HISTORIC AND DESIGN REVIEW COMMISSION

HDRC CASE NO: 2023-431
ADDRESS: 324 ADAMS ST
LEGAL DESCRIPTION: NCB 946 B-2 LOT SW TRI 12.3 OF 15,16 EXC NE & SW TRI & NE TRI 16.2 FT OF 17 ARB A14
ZONING: RM-4, H
CITY COUNCIL DIST.: 1
DISTRICT: King William Historic District
APPLICANT: Matthew Knapp/Elbow Room
OWNER: GONZALES ALAN J & LIBERTY A
TYPE OF WORK: New construction of a rear accessory
APPLICATION RECEIVED: October 23, 2023
60-DAY REVIEW: December 22, 2023
CASE MANAGER: Claudia Espinosa

The applicant is requesting a Certificate of Appropriateness for approval to construct a 480-square-foot rear accessory structure.

**exterior
elevations**

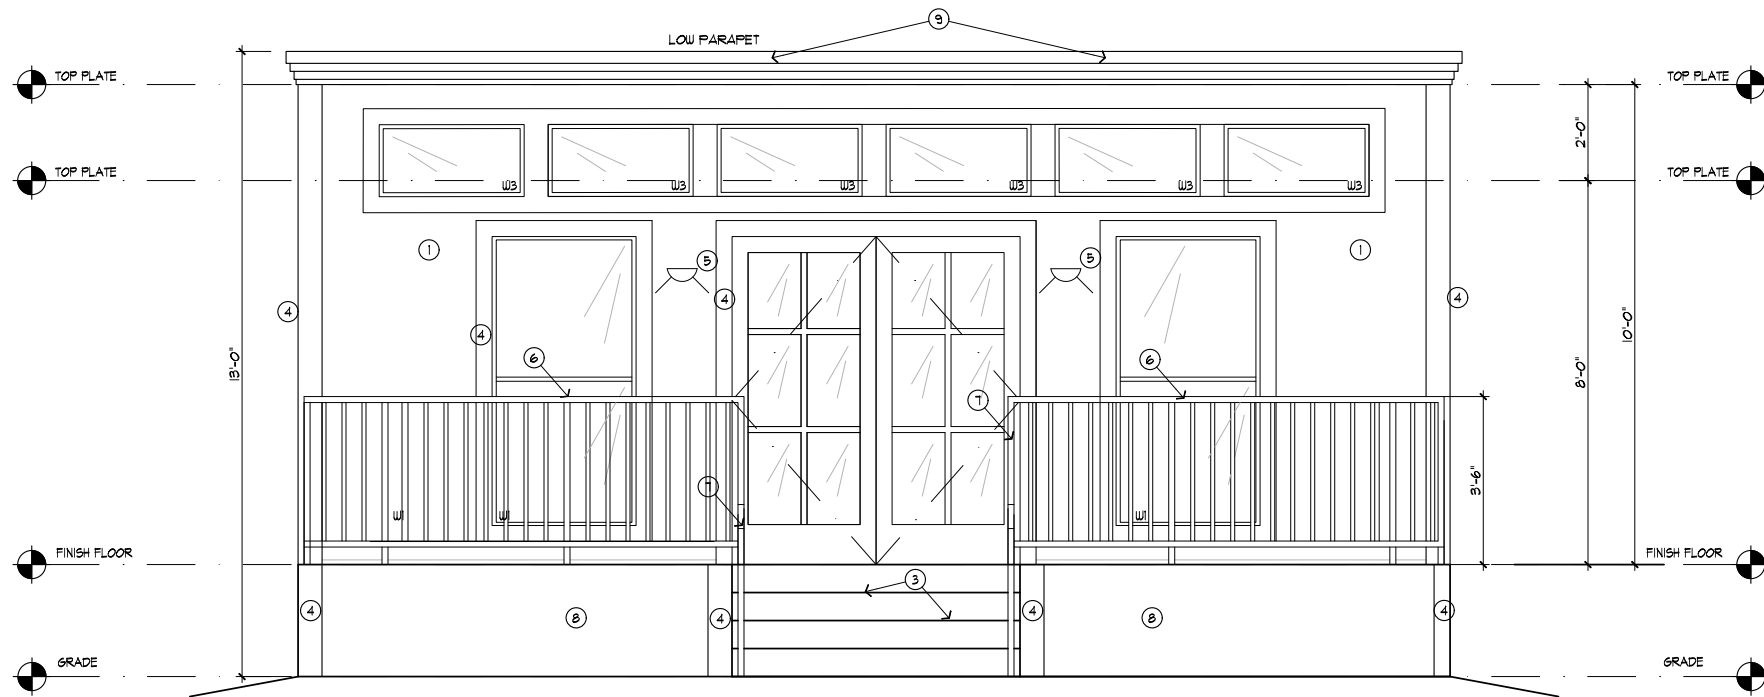
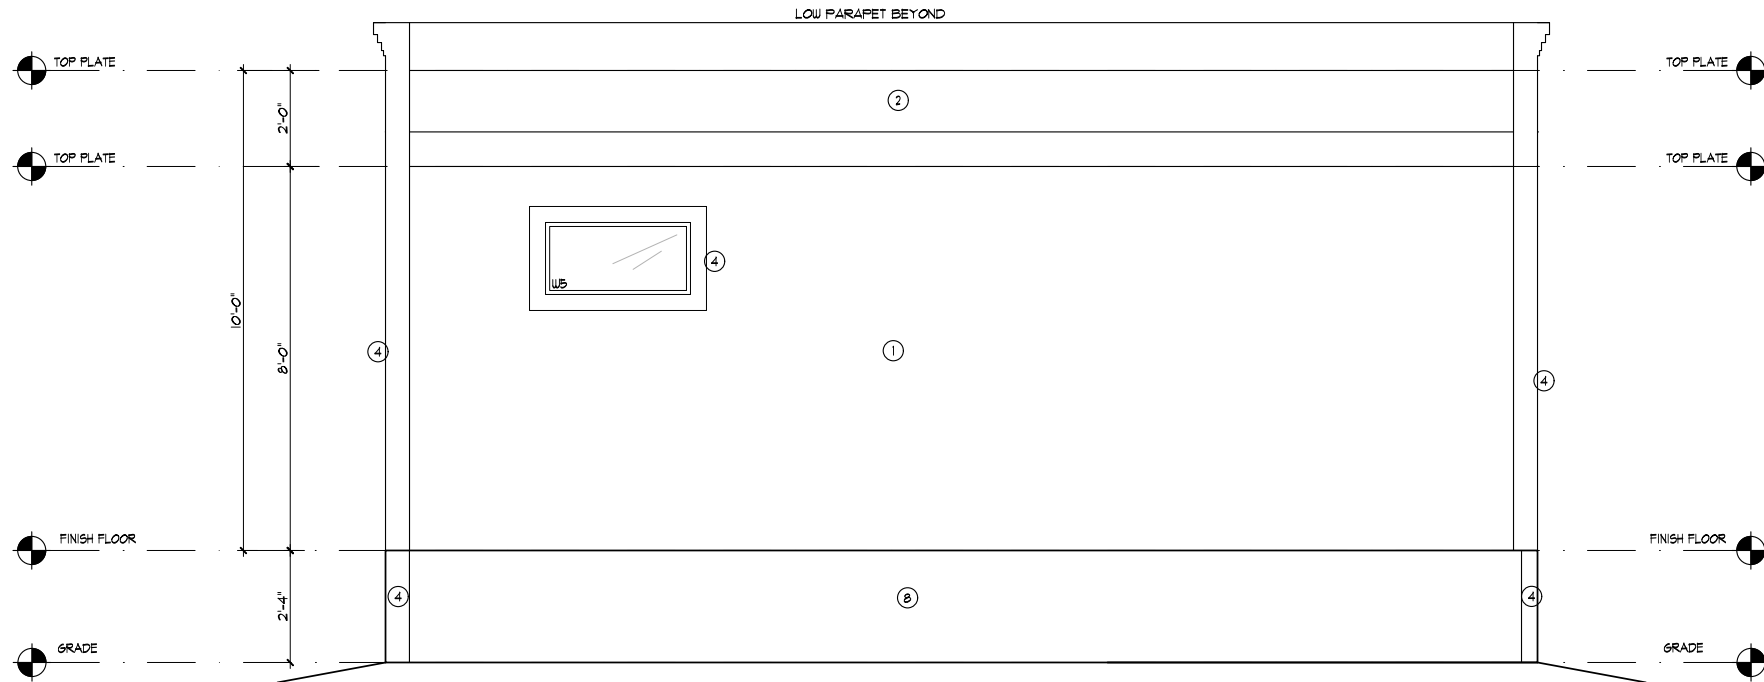
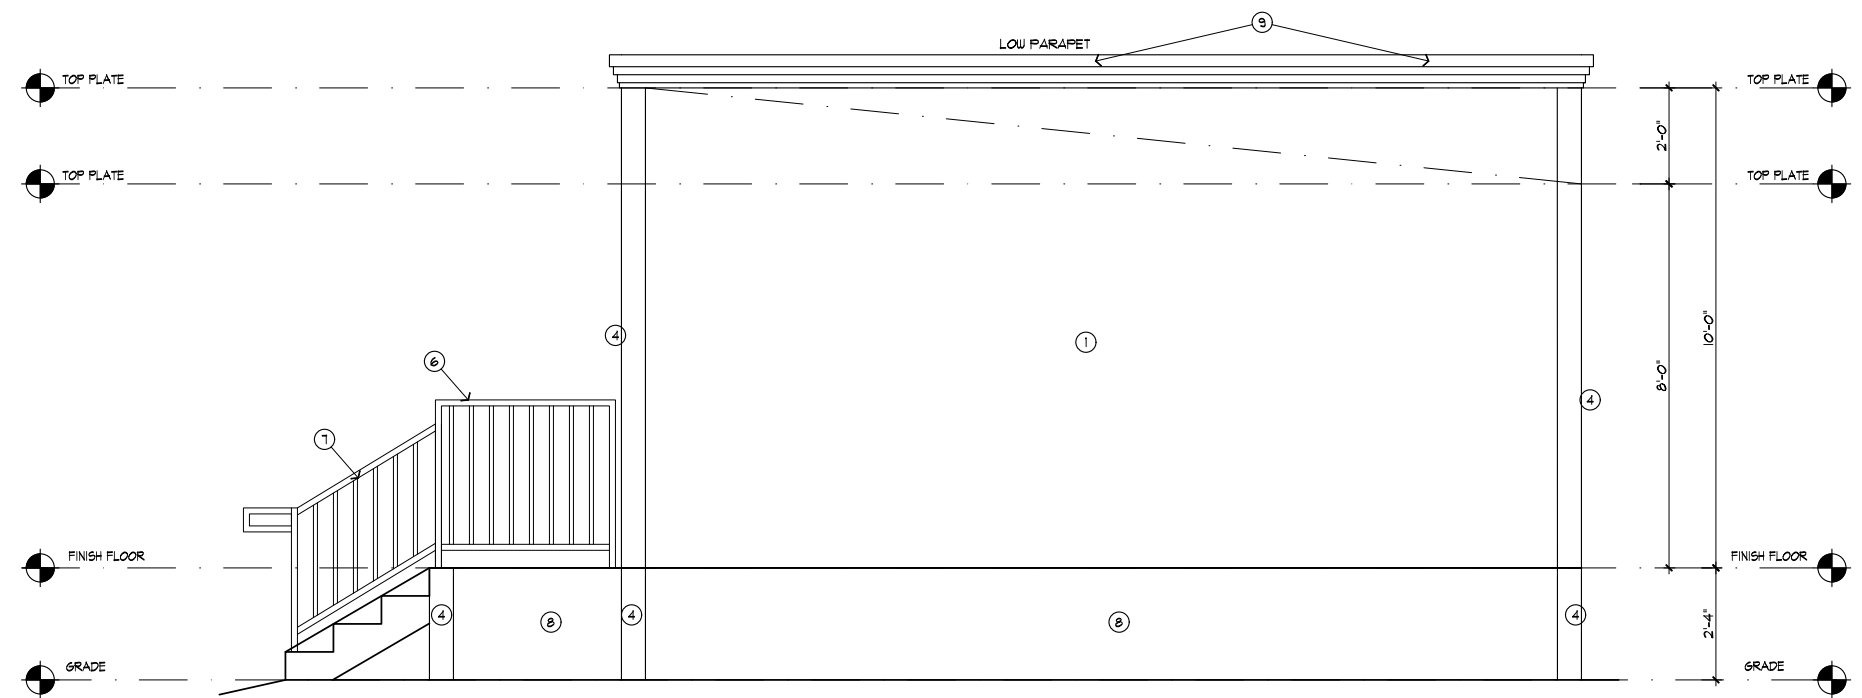
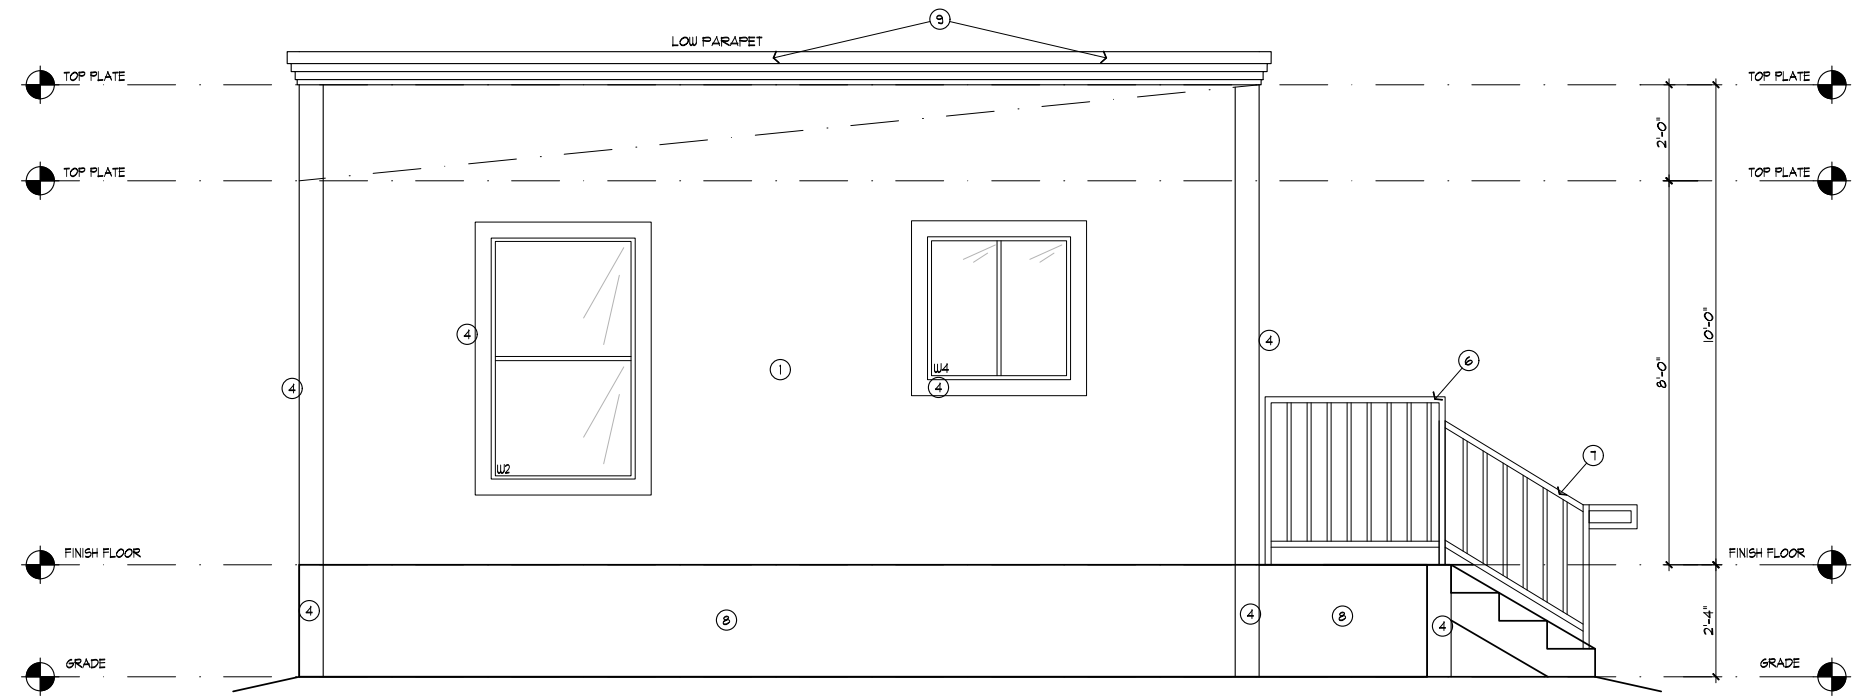
e. **MATERIALS & TEXTURES** – The applicant has proposed for the rear accessory structure to feature materials including aluminum-clad wood windows, stucco siding, wood trim, porch stairs, wooden railings, and a standing seam metal roof. Guideline 3.A.i for New Construction stipulates that new construction should use materials that complement the type, color, and texture of materials traditionally found in the district. Materials should not be so dissimilar as to distract from the historic interpretation of the district. For example, corrugated metal siding would not be appropriate for a new structure in a district comprised of homes with wood siding. Consider using traditional materials, such as wood siding, in a new way to provide visual interest in new construction while still ensuring compatibility. The adjacent historic structures generally feature wood siding or masonry and shingle roofing material. Additionally, Guideline 3.A.v, states contemporary materials not traditionally used in the district, such as brick or simulated stone veneer and Hardie Board or other fiberboard siding, may be appropriate for new construction in some locations as long as new materials are visually similar to the traditional material in dimension, finish, and texture. EIFS is not recommended as a substitute for actual stucco. The proposed materials will complement the primary structure which is fully clad in stucco. The proposal is generally appropriate.

g. **ROOF FORM** – The applicant has proposed to install a standing seam metal flat roof to the rear accessory structure. The Guidelines for New Construction 2.B.i. states that roof forms—pitch, overhangs, and orientation—consistent with those predominately found on the block should be incorporated. Staff finds the proposed roof is simple in design and generally consistent with the Guidelines.

h. **SOLIDS AND VOIDS** - The applicant has proposed to install aluminum-clad wood windows, on all but one elevation. Guideline 2.C.ii for New Construction states to avoid blank walls, particularly on elevations visible from the street. No new façade should exceed 40 linear feet without being penetrated by windows, entryways, or other defined bays. Additionally, Guideline 2.C.i for New Construction states that new construction should incorporate window and door openings with a similar proportion of wall-to-window space as typical with nearby historic facades. Windows, doors, porches, entryways, dormers, bays, and pediments shall be considered similar if they are no larger than 25% in size and vary no more than 10% in height to width ratio from adjacent historic facades. The proposed structure features a symmetrical fenestration pattern on the front façade, however, staff finds that the applicant explores additional fenestrations to the sides and rear of the structure.

- i. That the applicant installs a window that meet staff’s standard window stipulations and submits updated specifications to staff for review and approval prior to the issuance of a Certificate of Appropriateness based on findings g and r. The windows should feature an inset of two (2) inches within facades and should feature profiles that are found historically within the immediate vicinity. Meeting rails must be no taller than 1.25” and stiles no wider than 2.25”. White manufacturer’s color is not allowed, and color selection must be presented to staff. There should be a minimum of two inches in depth between the front face of the window trim and the front face of the top window sash. This must be accomplished by recessing the window sufficiently within the opening or with the installation of additional window trim to add thickness. Window trim must feature traditional dimensions and architecturally appropriate sill detail. Window track components must be painted to match the window trim or concealed by a wood window screen set within the opening, based on finding f.

- ii. That the applicant installs a standing seam metal roof featuring panels that are 18 to 21 inches wide, seams that are 1 to 2 inches high, a crimped ridge seam, and match the current finish or a standard galvalume finish, based on finding d. Panels should be smooth without striation or corrugation. Ridges are to feature a double-munch or crimped ridge configuration; no vented ridge caps or end caps are allowed. All chimney, flue, and related existing roof details must be preserved. An inspection must be scheduled with OHP staff prior to the start of work to verify that the roofing material matches the approved specifications.

PLY GEM
5020 WESTON PKWY
CARY, NC 27513
TOLL FREE: 1-800-975-9436
www.plygem.com

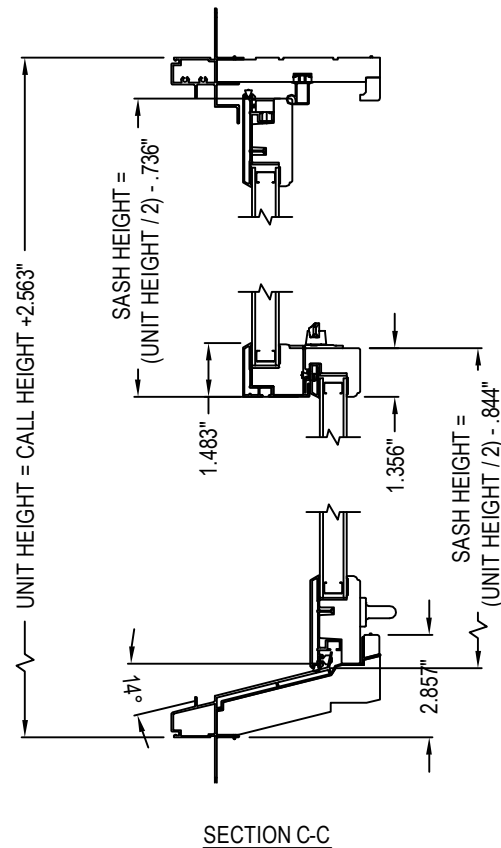
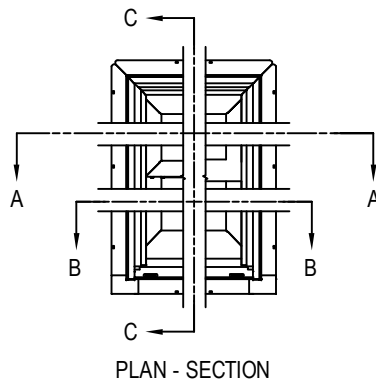
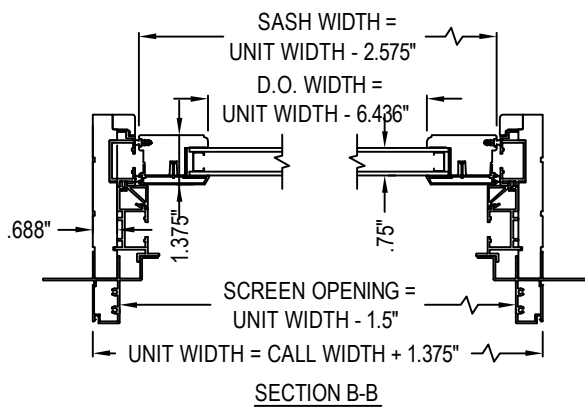
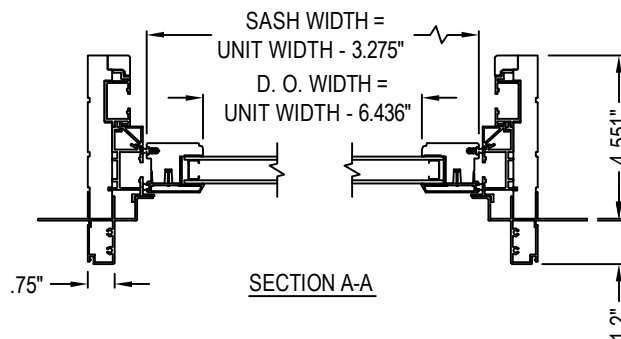
f. **WINDOW MATERIALS** – The applicant has proposed to install double-hung aluminum-clad wood windows. The proposed windows sashes are to be recessed two (2) inches behind the face of the trim. Wood or aluminum-clad wood

windows are recommended and should feature an inset of two (2) inches within facades and should feature profiles that are found historically within the immediate vicinity. An alternative window material may be proposed, provided that the window features meeting rails that are no taller than 1.25” and stiles no wider than 2.25”. White manufacturer’s color is not allowed, and color selection must be presented to staff. There should be a minimum of two inches in depth between the front face of the window trim and the front face of the top window sash. This must be accomplished by recessing the window sufficiently within the opening or with the installation of additional window trim to add thickness. Window trim must feature traditional dimensions and an architecturally appropriate sill detail. Window track components must be painted to match the window trim or be concealed by a wood window screen set within the opening. Staff finds the proposed window is larger than the generally recommended. The Guidelines for New Construction 5.A.iv, states to design window and door openings to be similar to those found on historic garages or outbuildings in the district or on the principle historic structure in terms of their spacing and proportions. Staff finds that the applicant should explore a traditionally sized window that is in keeping with the Guidelines.
